**Subject: Palo Verde Nuclear Generating Station (PVNGS)
Unit 2 and Unit 3, Docket Nos. STN 50-529 and STN 50-530
Core Operating Limits Report (COLR), Unit 2-Revision 8
and Unit 3-Revision 11**

PVNGS UNIT 2 CORE OPERATING LIMITS REPORT

Revision 8

Revision 11

FIGURE 3.2.4-2
 DNBR MARGIN OPERATING LIMIT BASED ON
 THE CORE PROTECTION CALCULATORS
 (COLSS OUT OF SERVICE, CEAC's OPERABLE)

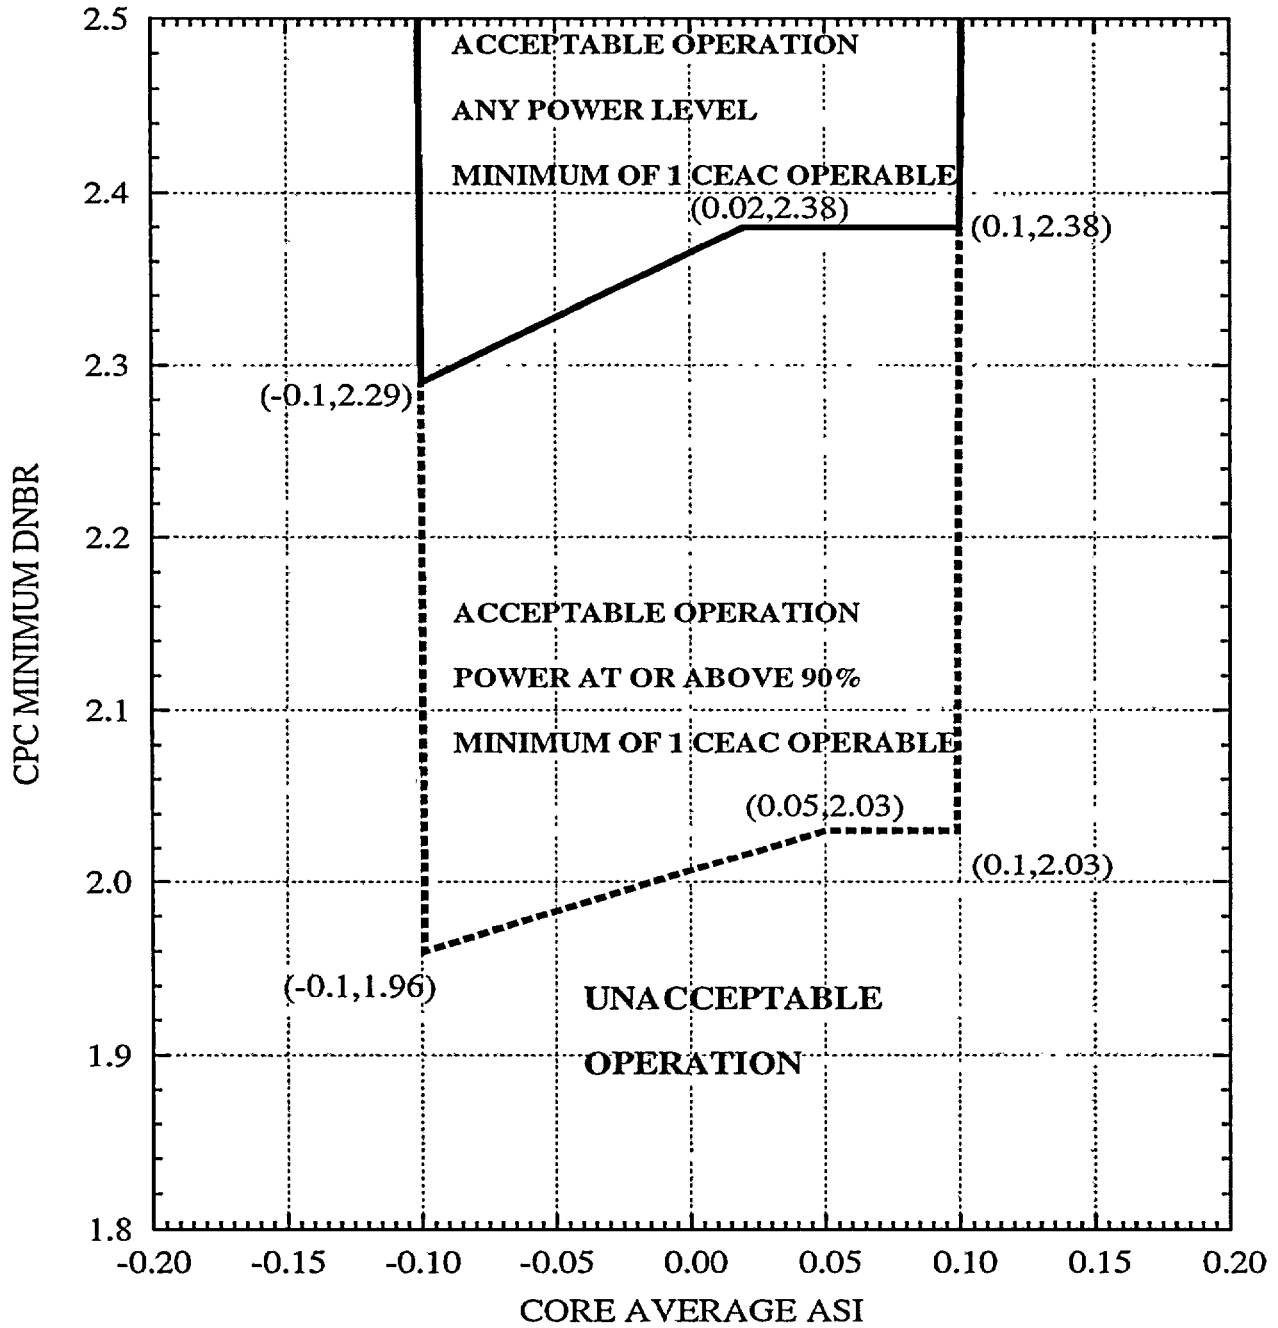
Pursuant to PVNGS Technical Specifications, Section 5.6.5.d, Arizona Public Service Company (APS) is providing the NRC with Revision 8 to the COLR for Unit 2 and Revision 11 to the COLR for Unit 3, which were made effective on April 15, 2003. The revisions to the Unit 2 and Unit 3 COLRs deleted Figure 3.2.3-1, "Azimuthal Power Tilt Versus Power (COLSS In Service)". This limit is now contained in the COLR section 3.2.3 describing the operating limit for "Azimuthal Power Tilt (T_q)". In addition, the limits associated with ASI (Axial Shape Index) in section 3.2.5 and the minimum departure from nucleate boiling ratio (DNBR) contained in Figure 3.2.4-2 "COLSS Out of Service Based on the Core Protection Calculators" were changed for the Unit 3 COLR.

COLSS OUT OF SERVICE and Either One or Both CEACs are OPERABLE - Operating within the region of acceptable operation of Figure 3.2.4-2 using any operable CPC channel.
